COORS/ARENAL PARK - LOT 10
GRADING PLAN
ALBUQUERQUE, NEW MEXICO

GRADING PLAN

C-101

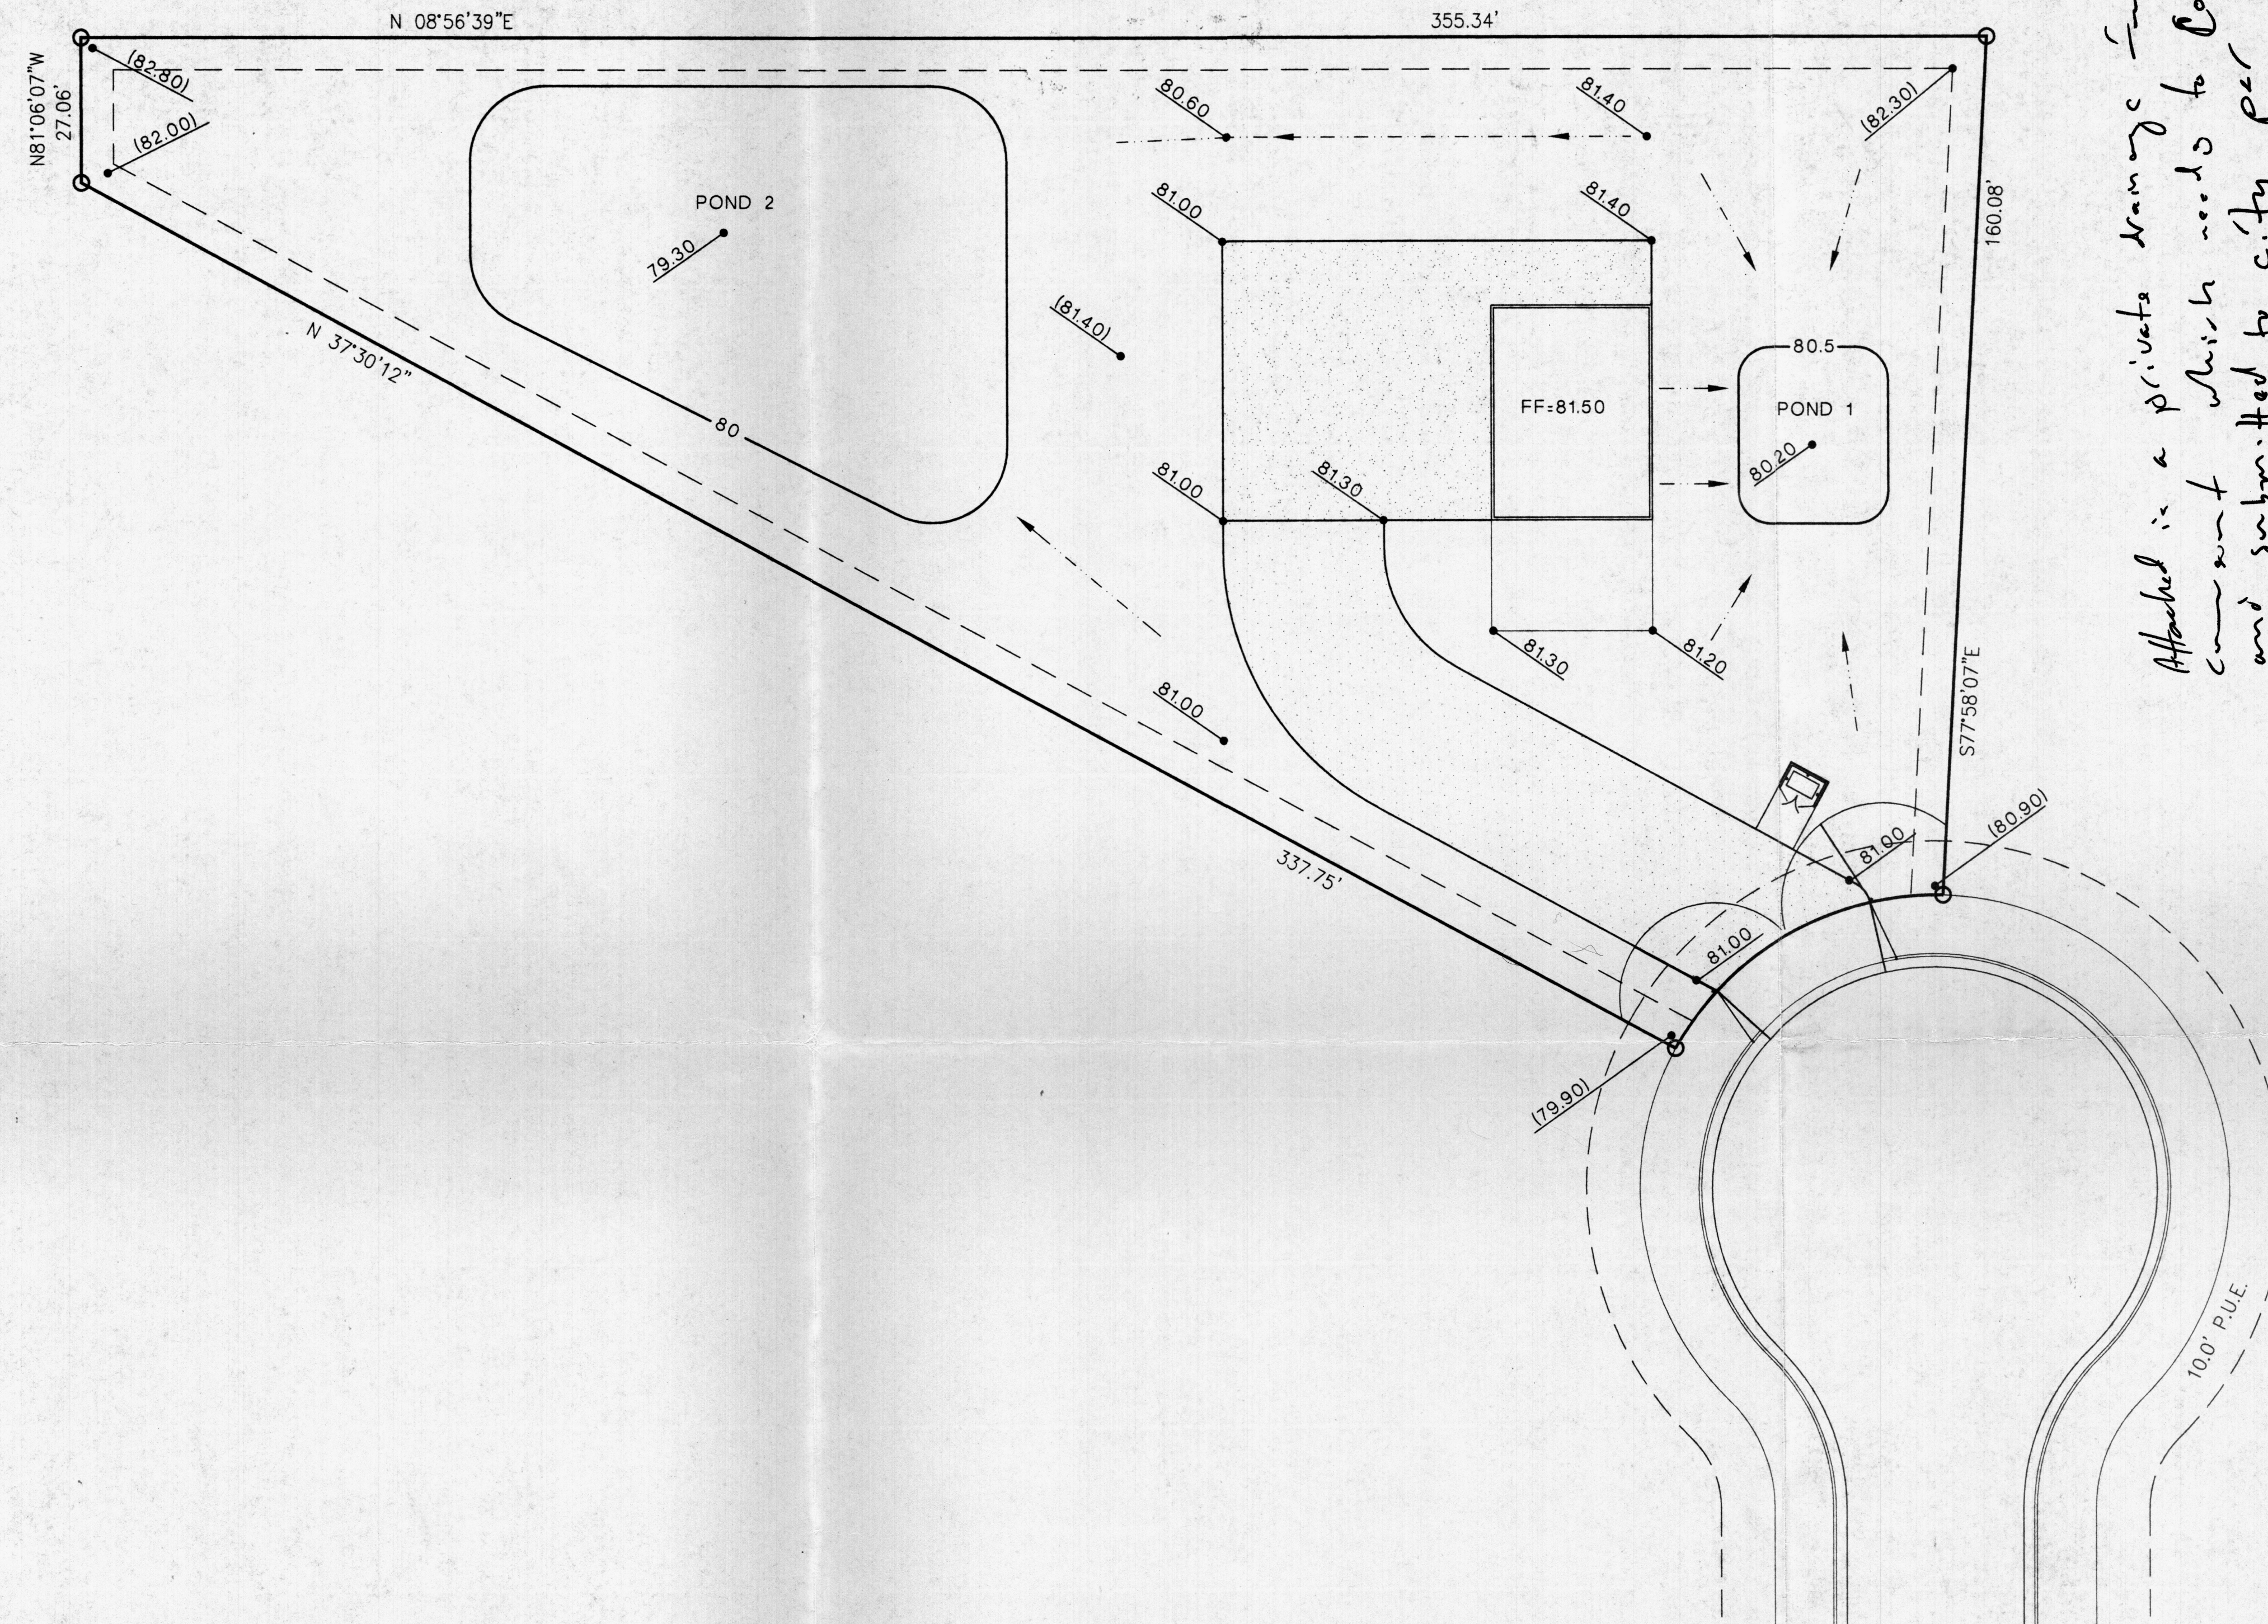
Attached is a private drainage twenty
cunant which needs to be completed
and submitted to city per _____
Cathy L. Smith
